**Group of Experts on European Agreement Concerning Work of
Crews of Vehicles Engaged in International Road Transport (AETR)**

Annex 1C

Submitted by the European Commission

This document, submitted by the European Commission, contains amendment proposals (identified in track changes) which aim at modifying the EU “Annex IC” to create Appendix 1C of the AETR Agreement.

Figure 1 Different configurations for GNSS receiver.

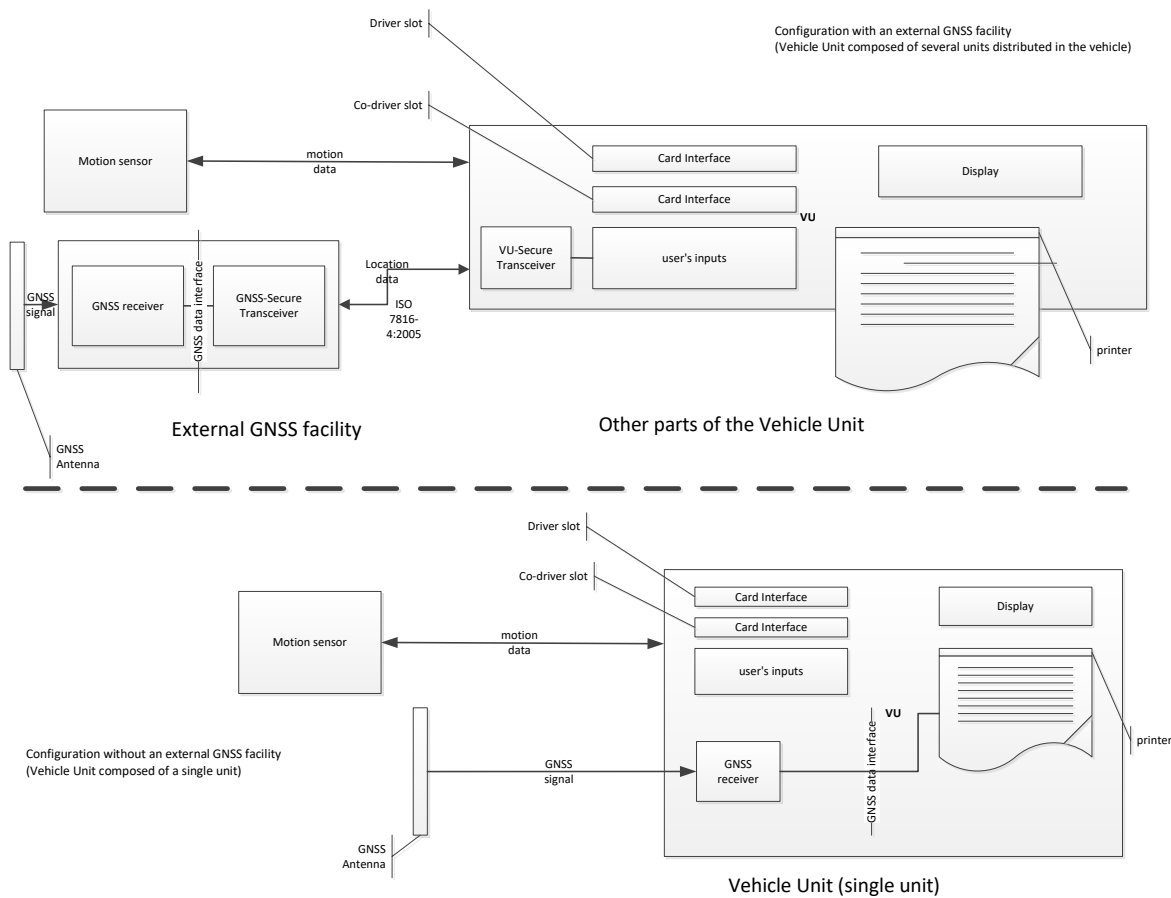
The Vehicle Unit may be with or without an external GNSS facility as described in ~~Figure 1~~Figure 1:

Figure 4 Schema of the external GNSS facility

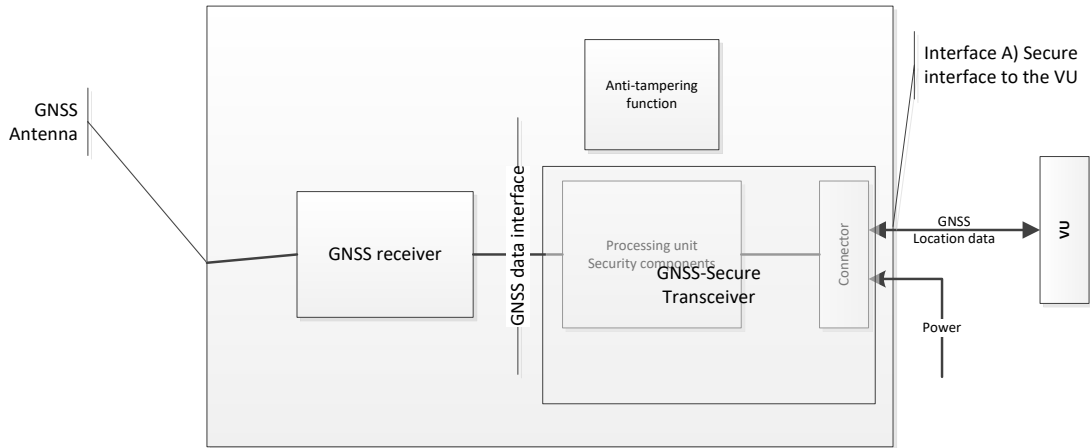
In this configuration, the GNSS receiver is inside the Vehicle Unit as described in [Figure 1](#) [Figure 4](#).
